UNITED STATES PATENT AND TRADEMARK OFFICE

10/784,759

Office Action Summary

DETAILED ACTION

Fig 1.

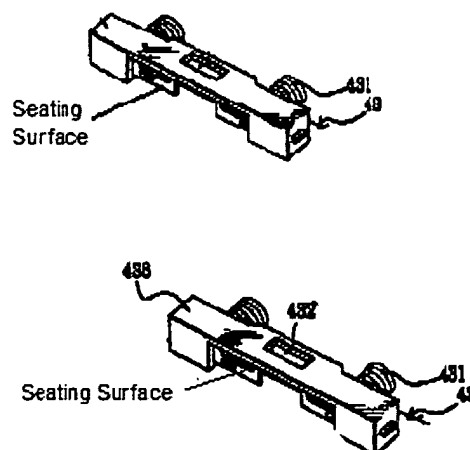
15. With respect to claim 18, Hsu et al. further teaches a pressure member (436) seated in the seating groove (443) and having a seating surface (See Fig 1) on one side thereof determining one side of the passage hole, and a resilient member (431) coupled to another side of the pressure member (436).
